DEPARTMENT OF PLANNING
STAFF REPORT

PLANNING COMMISSION PUBLIC HEARING

SPEX 2009-0017, CMPT 2009-0004

LOUDOUN COUNTY PUBLIC SCHOOLS (MS-5)

Figure 1. Special Exception Plat

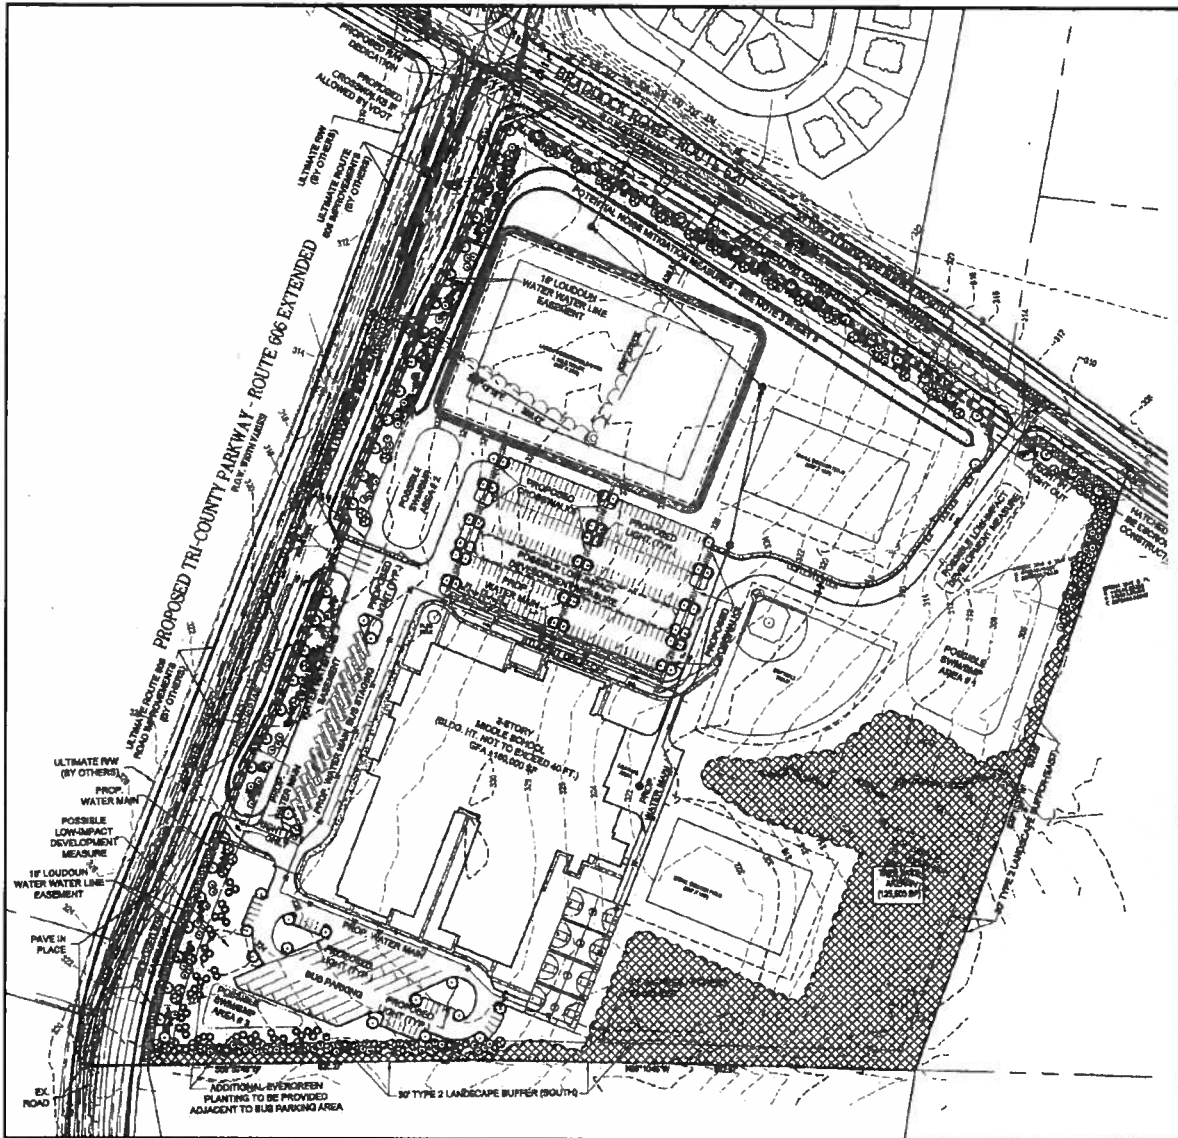
The Applicant has generally placed the school building in the southern portion of the site with athletic fields, natural spaces, and parking around the periphery. The school is planned as two-story structure with maximum height of 40 feet and a footprint of approximately 420' x 460'. Tree Save Areas along the eastern and southern property boundaries have been identified on the Plat. The Special Exception Plat shows landscape buffers along the northern and western property boundaries that are in excess of the Zoning Ordinance standards (Type 3 vs. Type 2). Additional evergreen plantings are shown adjacent to the southern bus parking area.

Staff has made several recommendations regarding the use of building fenestrations and additional landscape plantings to break up several large building segments as well as reduce visual impact of the school facilities. Additional landscape treatments are also recommended to help mitigate the impact of traffic noise on athletic fields adjacent to Braddock Road and Ticonderoga Road. Conditions of approval reflect these recommendations. Staff continues to evaluate the Applicant's response.

Staff recommended that the Applicant depict the existing and planned pedestrian and bicycle network on the Plat; specifically, pedestrian and bicycle facilities along internal roads, Braddock Road, and Ticonderoga Road. Staff further recommended that sidewalks/trails be provided on both sides of all internal roads and that safe crossing facilities are provided at all intersections. Where a portion of a shared-use path will not connect to an adjacent parcel for the indefinite future, such as at the southwest corner of the site, a reservation may be more appropriate than the construction of that portion of the shared-use path to preclude unnecessary maintenance costs.

In response, the Applicant has depicted trail and sidewalk improvements along the project's internal roads and Braddock and Ticonderoga Road, crosswalks at intersections, and a trail connection and crosswalk to the South Riding Development north of the site. A separate onsite track will be provided. The Applicant also proposes to provide right-of-way and a cash contribution (\$16,800) where portions of a shared-use path along Braddock Road and Ticonderoga Road will not connect to an adjacent parcel. These commitments have been either identified on the special exception plat or listed as a condition of approval. Staff continues to evaluate the Applicant's response to Staff recommendations.
